Addendum Addenda

| No./No 1 |

| Project Description / Description de projet U61 - Free Cooling & Chiller Replacement | | |
| Project No./No de projet 5886 | Departmental Representative / représentant ministériel Benoit Huot | Date 13-Oct-2021 |

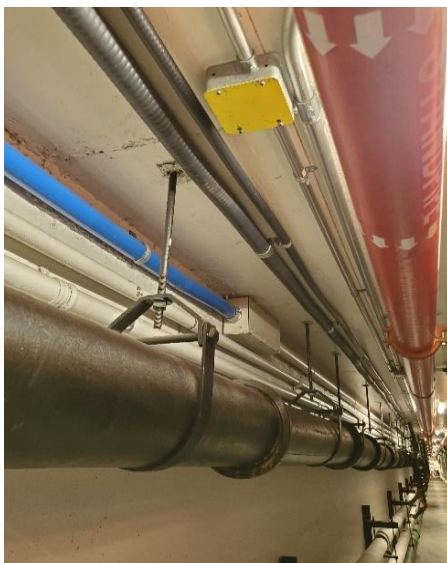
We would like to request that Urecon be considered an alternate to the Perma-Pipe system specified on this project. See attached spec sheet for

_ Proposed product is not an approved alternate to the specified pipe. The system proposed uses a tape jacket and the specified product is a seamless extruded jacket. The jacket thickness for the specified product is 100mils up to 12in diameter, the proposed jacket is 50mils up to 16in diameter.
